APPLICATION FOR SITE PLAN REVIEW

**TO THE CITY OF PORTSMOUTH
FOR 94 LANGDON ST. & 98 CORNWALL ST.**
Map 139, Lots 1 & 8 | Portsmouth, NH

**RE: Request for Planning Board Review
94 Langdon Street & 98 Cornwall Street
Proposed Multifamily Development**

Listed below are the Conditions of Approval obtained at the April 7, 2026 TAC meeting, with the initial condition repeated and the response in **bold** text:

DATE	SCALE
DECEMBER 2025	1"=20'
DRAWN BY: RJB	DESIGNED BY: ---
CHECKED BY: PAY	
PROJECT No: 5010220.04	FIELD BOOK/PAGE: FB 443 PG 17
DRAWING No: V101	REV: 4

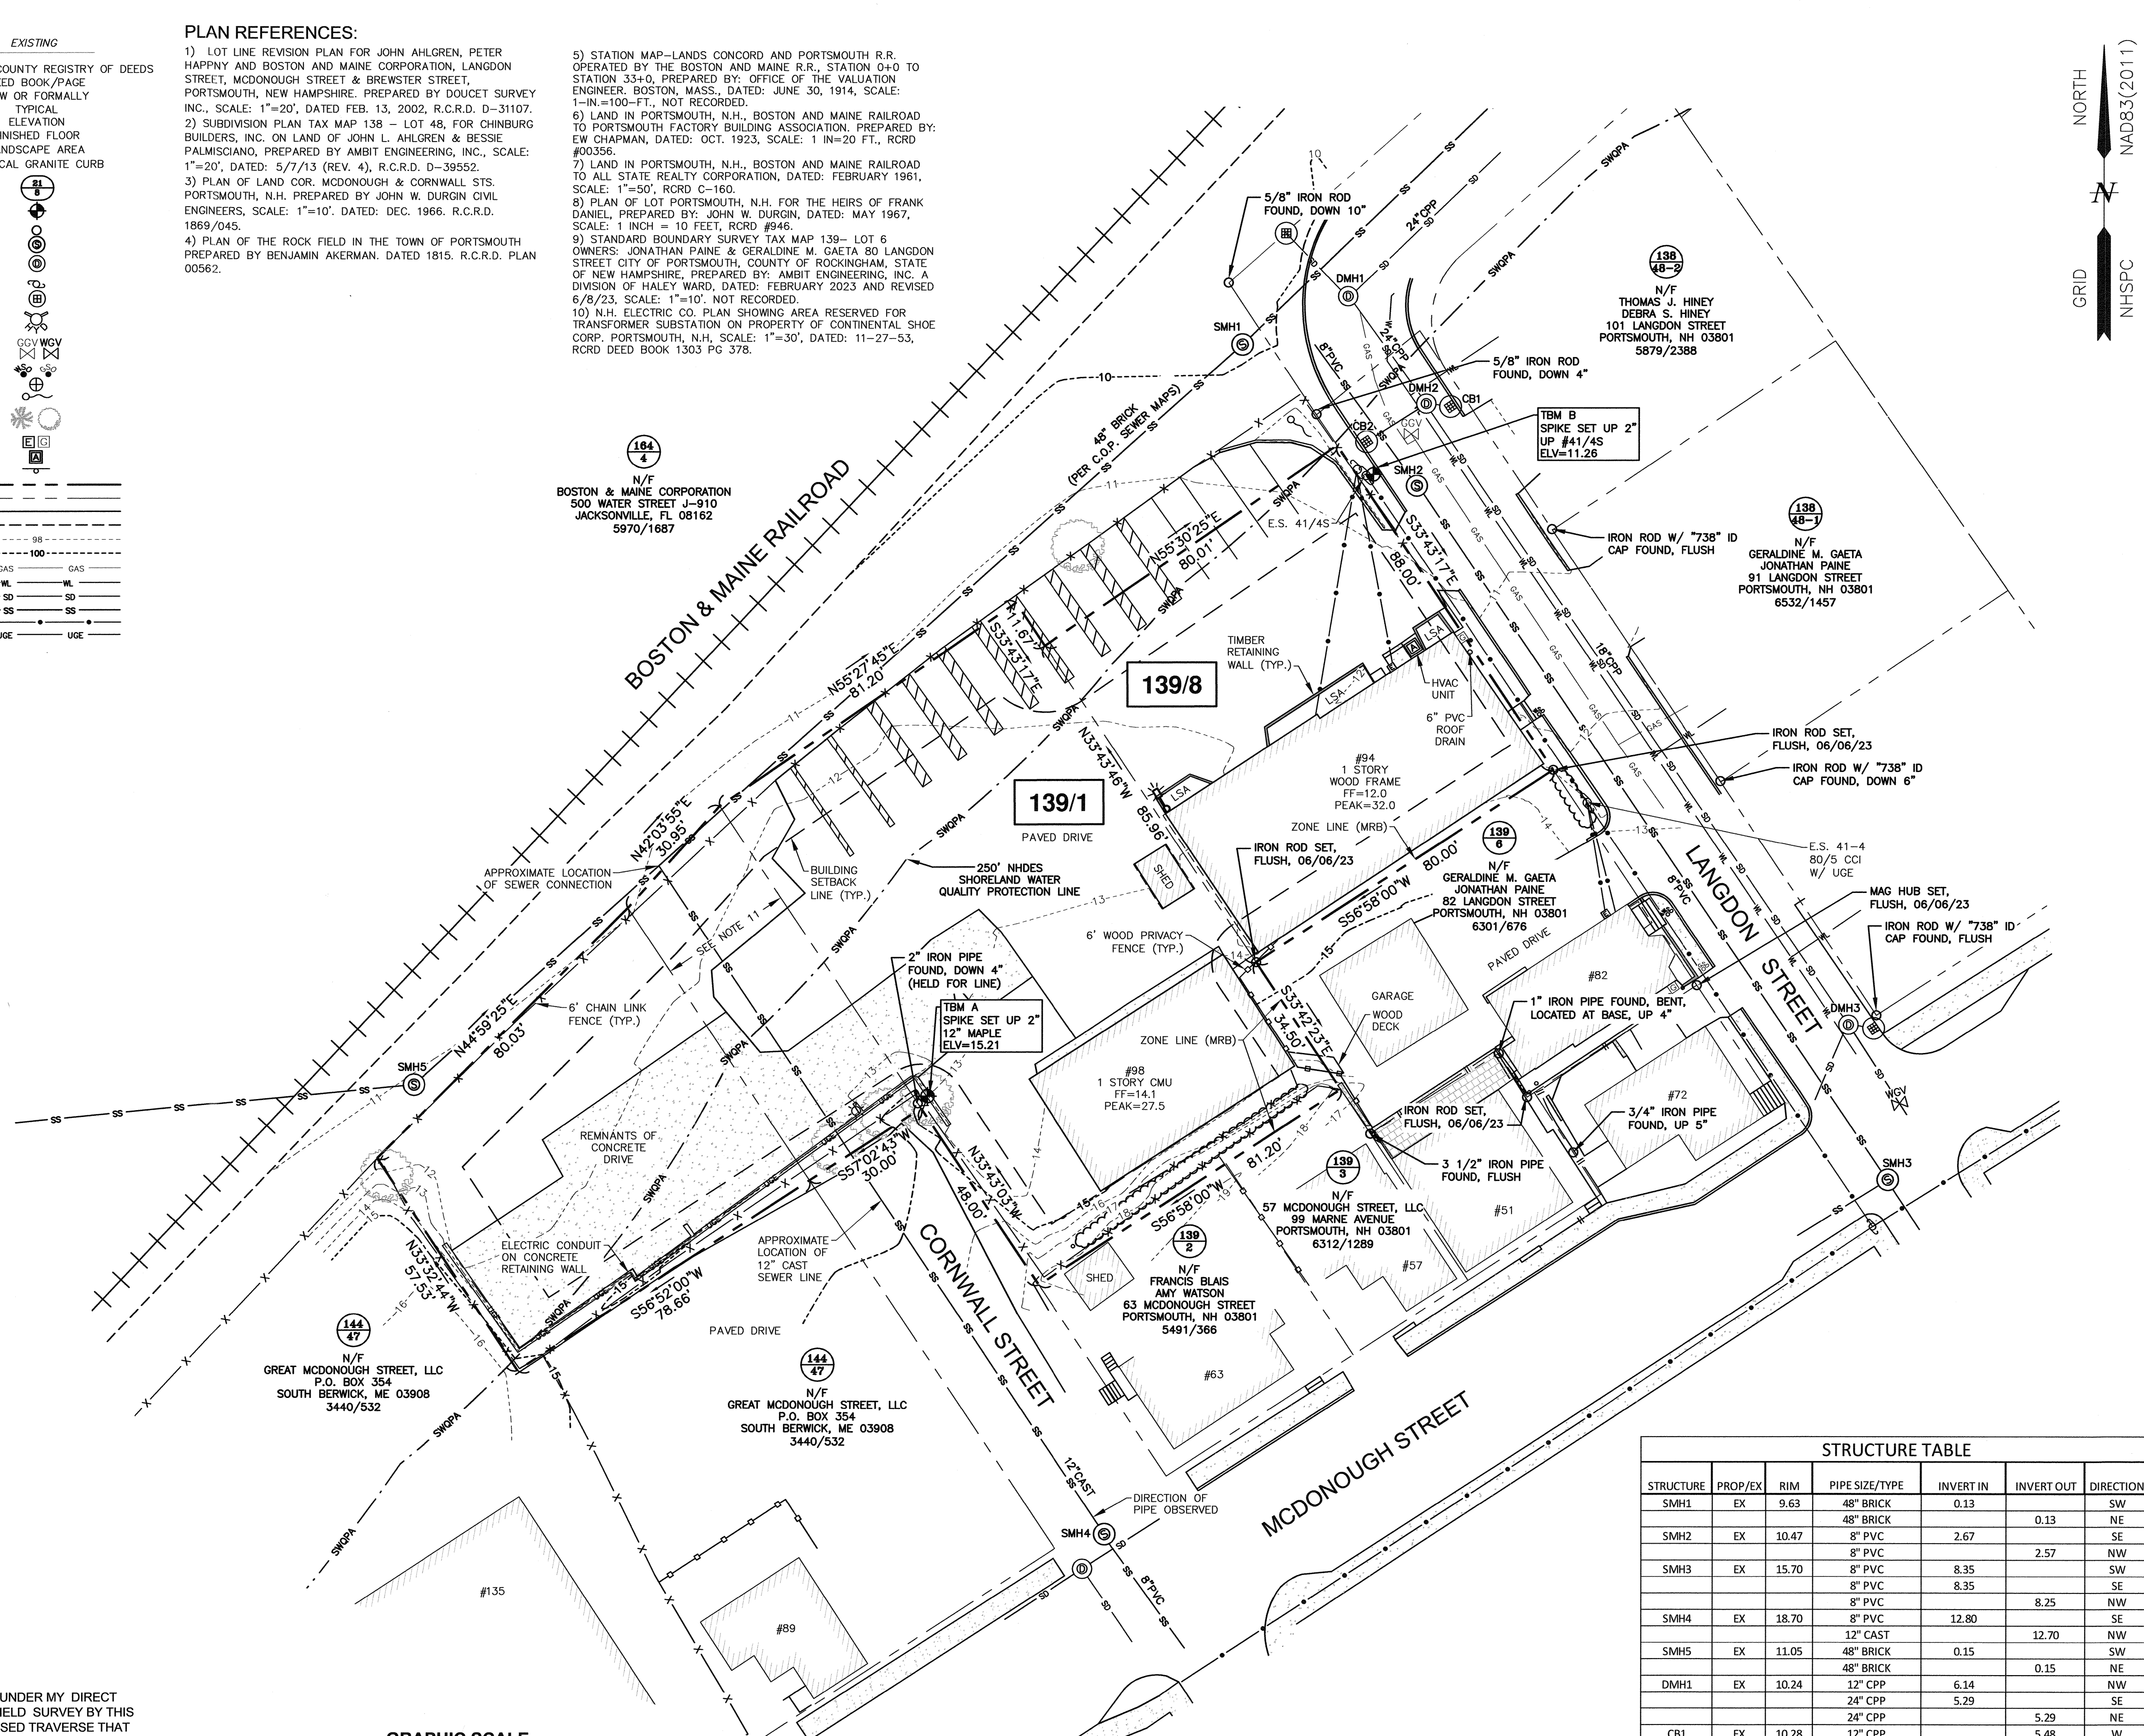
2. Show existing 10-12" sewer main crossing the lot on Cornwall Street and consider sewer connection there. An easement to the City is required for the sewer main pipe crossing the lot on Cornwall Street.

The existing sewer line was field verified as a 12" cast iron line and has been added to Drawing V101, Existing Conditions Plan. A proposed 20' wide easement centered on the existing pipe is shown on the Sewer Easement Plan.
